Proposal for amendments to UN Regulation No. [151]

(Revised version of informal document GRSG-117-24 (modified in session))

“Figure 1
Dynamic tests

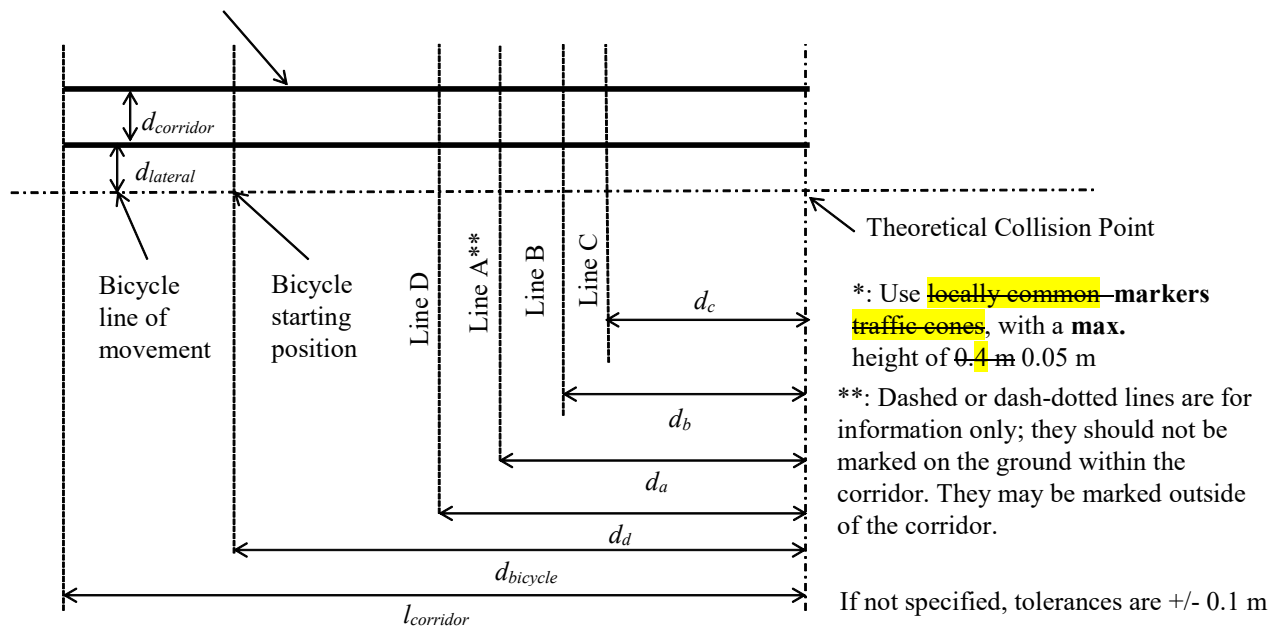
Annex 1, Appendix 1, Figure 1, amend to read:

Mark corridor using **cones markers** *, spacing not more than 5 m

1. Not warning for static objects, like traffic cones, is an important part of the properties of the blind spot regulation. However, as the current test specification was written, the cones, because of their height, may obstruct the view of the system towards the bicycle. That would prevent the system from tracking the moving bicycle dummy and thereby make the system fail the test. This is even more likely to happen if the cones are placed within a short distance from each other.

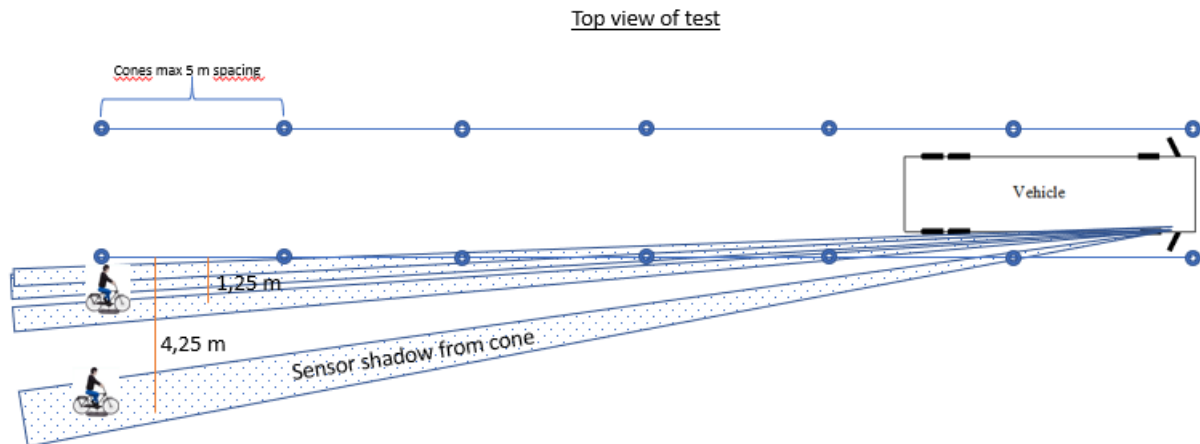
2. As a result of how the test case 3 and 5 are designed (equal speed of vehicle and bicycle dummy), no first point of information (D_d) will exist. The bicycle dummy will need an acceleration distance to reach the defined speed. This will result in an adjustment of the starting point of the bicycle and therefore the given value for first point of information will not be correct anymore.
